RE: UDC district narrative  
444 S. Park St, Madison, WI.

On behalf of Rockhound Brewery and Lanes, LLC, Shulfer Architects, LLC is submitting this narrative and application for approval of the proposed changes to the building located at 444 S. Park St. We are seeking approval for the proposed MEP equipment screen located on the rooftop of "The Dude" apartment buildings. This is a change to an already approved plan.

**1 ROOF PLAN**  
NOT TO SCALE

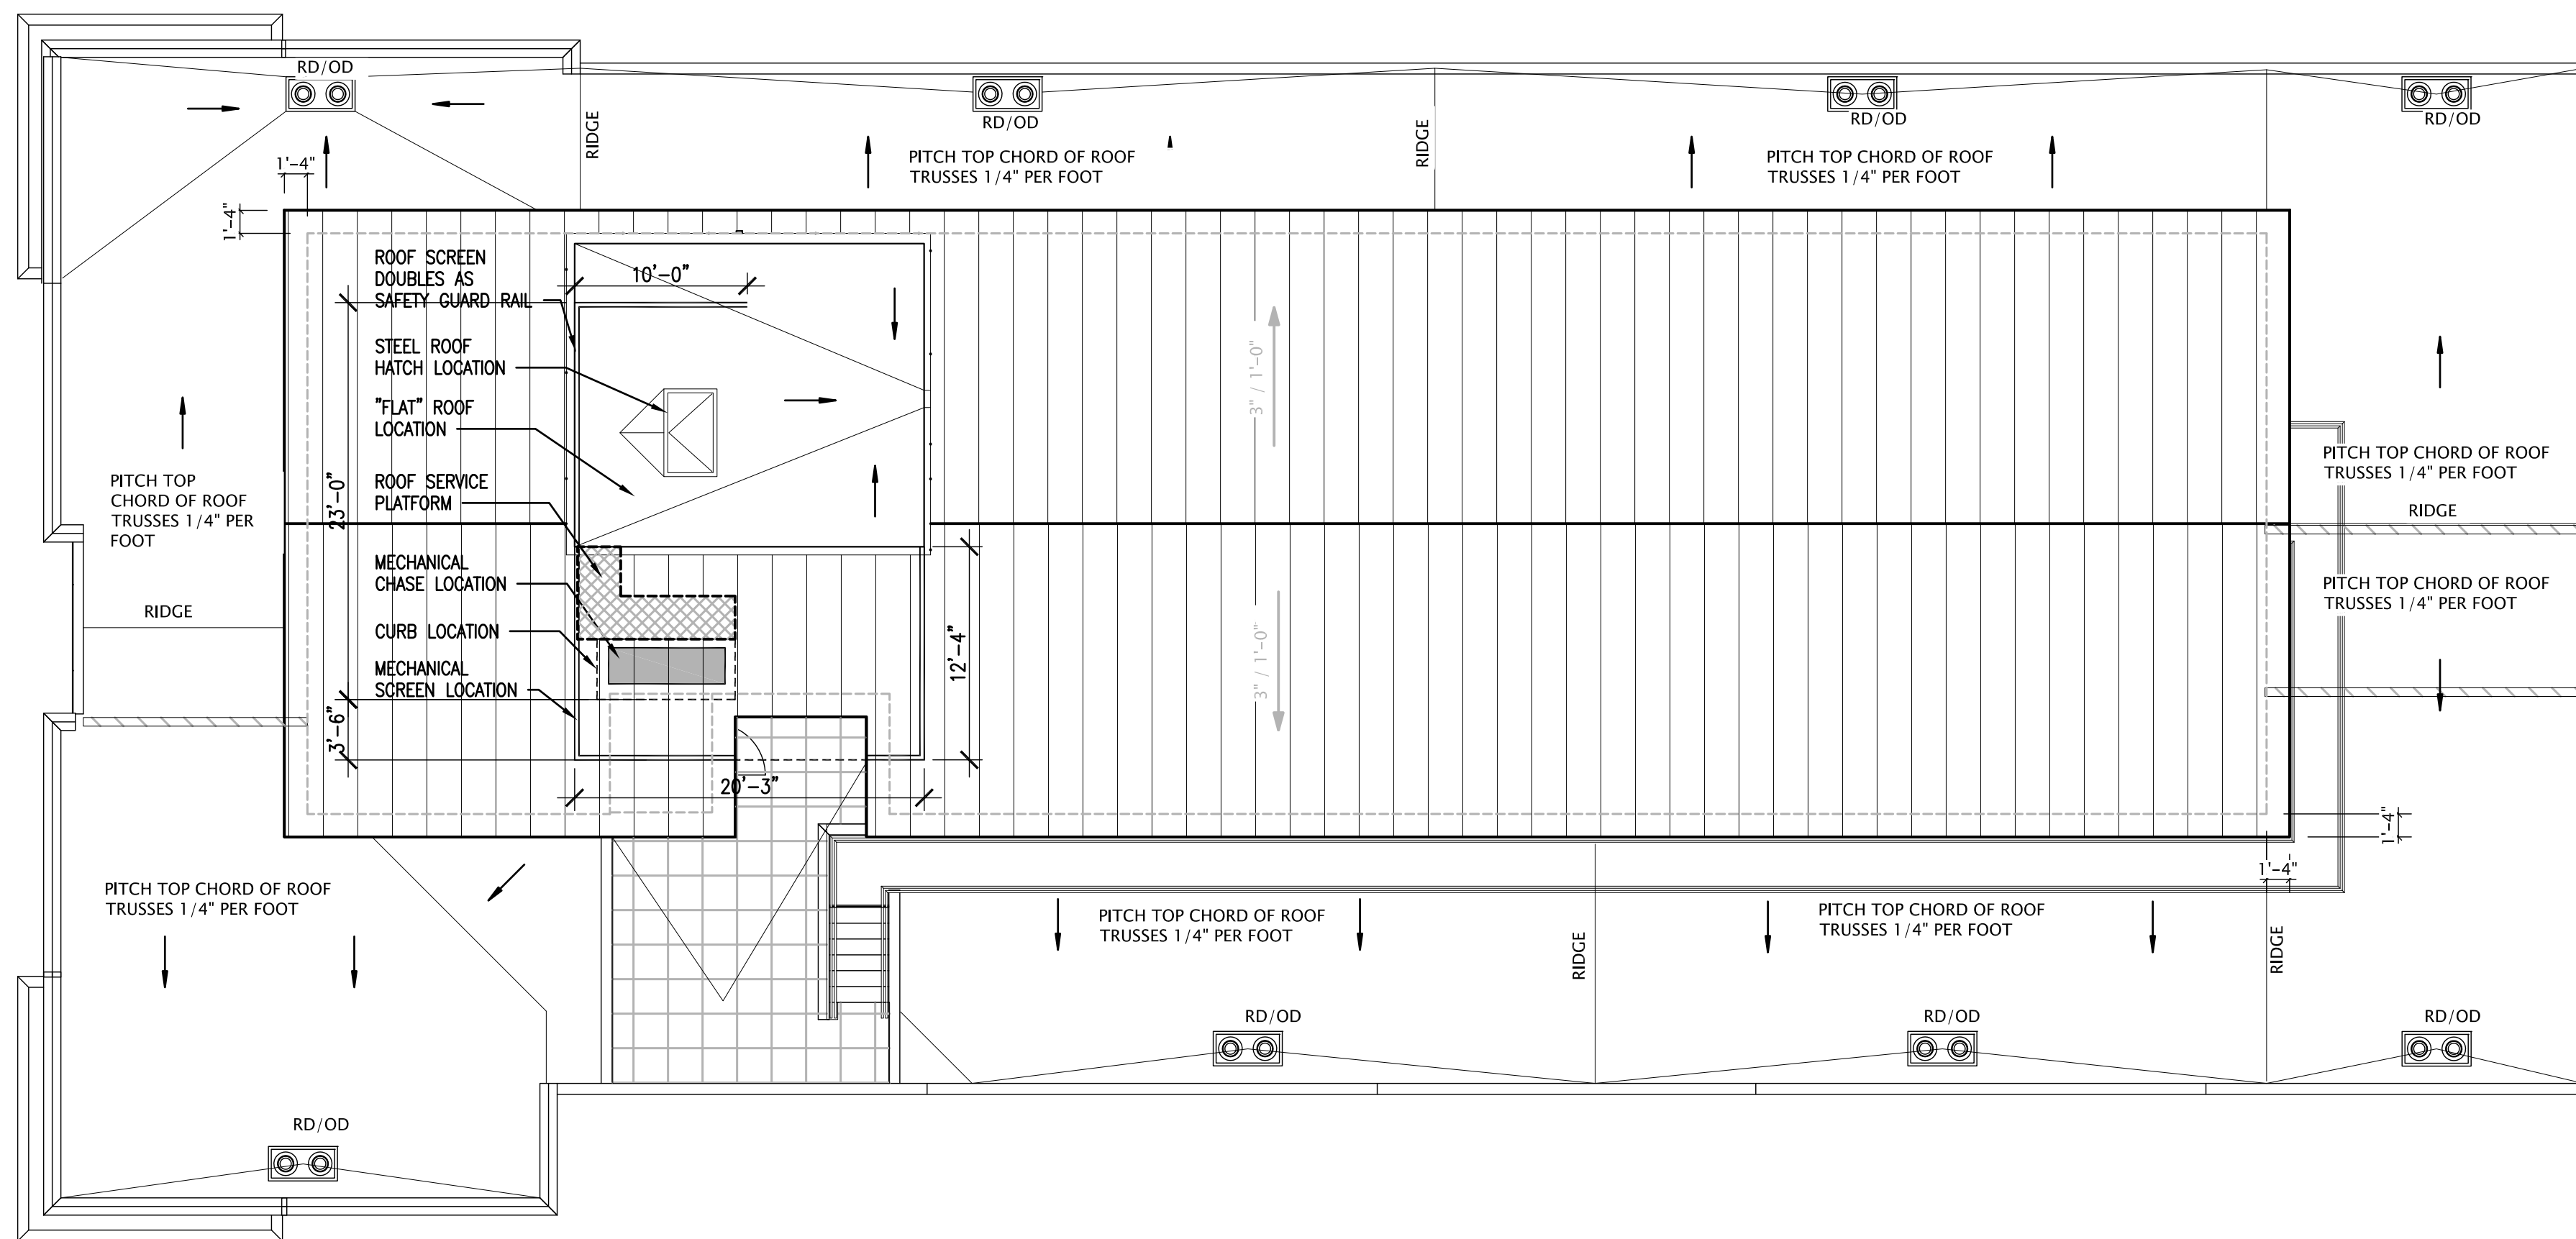
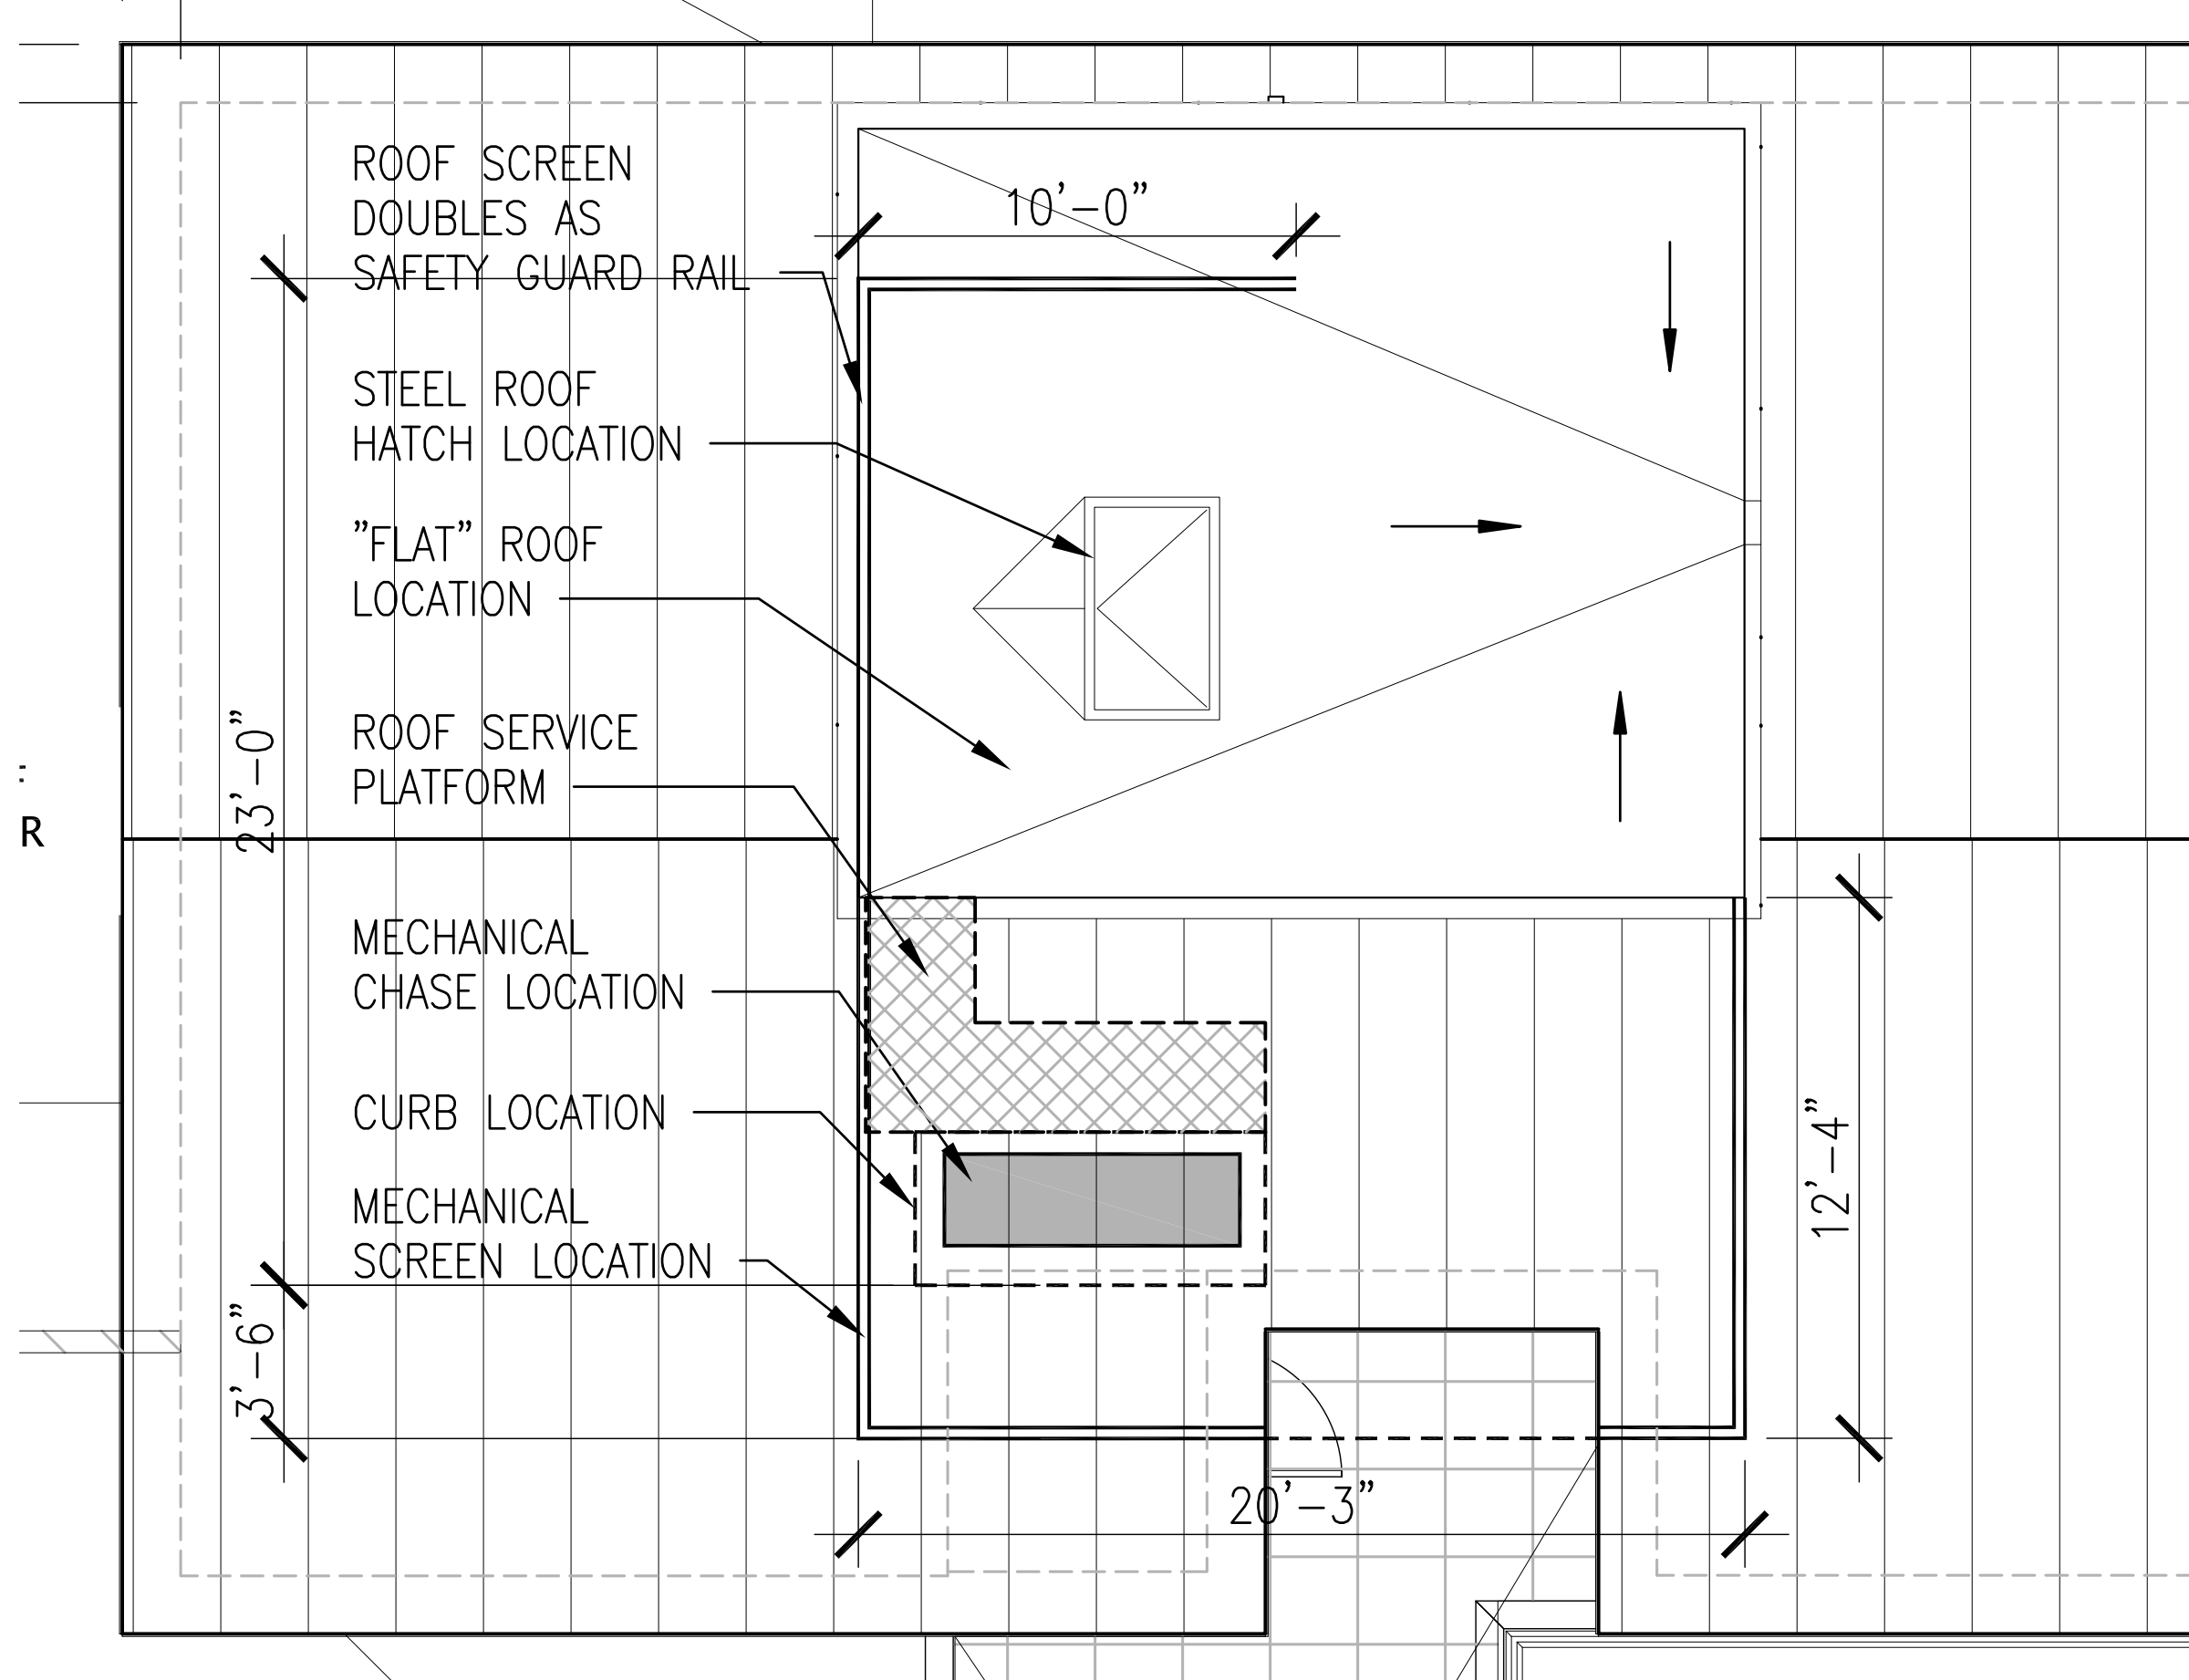
**Proposal Summary:** This building is zoned PD and is a mixed-use, multi-tenant apartment building. Rockhound Brewery is a new brew-pub tenant. The requirements of the restaurant and brewery require exhaust ventilation. A mechanical chase and curb was provided in the building design for the possibility of a restaurant tenant in the space now occupied by Rockhound Brewery. The exhaust equipment is located on the roof above the provided chase and on the curb. The way the building was designed there is no other reasonable location for the exhaust fans. In addition a guard rail will need to be installed for roof access. Our proposal is to use the screen as the guard rail thus eliminating the need for another component on the roof. An equipment access platform will also be required. We propose to screen this as well as the exhaust equipment.

As outlined in the attached documentation, ventilation for the restaurant and brewery equipment is required and vented to the roof through the existing chase, as required by code, and supported by approved HVAC plans through the City of Madison. The equipment on the roof will be screened, as outlined in the attached documentation.
